BCA ASSESSMENT REPORT

2-30 Tempus Street, Rouse Hill NSW 2155

Project Number: 120222

Revision: 2.1

Figure 9 – BTR Tower Fire-Isolated Stair Discharge Locations

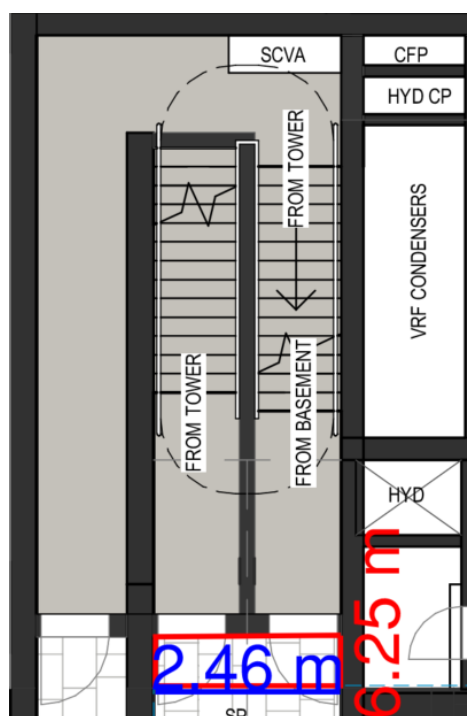
It is noted that fire-isolated stair cores provided to the BTR towers will include discharge locations for the stairs which are into covered areas that are required to be open for 1/3 of their perimeter and achieve an unobstructed ceiling height of 3.0m. The plans provided indicate that the discharge locations will not be open for 1/3 of their perimeter (as indicated in Figure 9 below) but they appear to achieve the required unobstructed height. The fire-isolated stair discharge locations are required to be addressed under a fire engineered performance solution.

The discharge arrangement for the Western Co-Living stair core appears to demonstrate that adequate separation is provided between the stair flights rising from Basement Level 1 and the flights descending from Level 1.

The Eastern Co-Living stair is noted to discharge into a location that will require occupants to pass within 6m of unprotected openings in the external walls of the same building (the vehicle entrance ramp due to the opening between columns). It is proposed to permit the current discharge arrangement under a fire engineered performance solution.
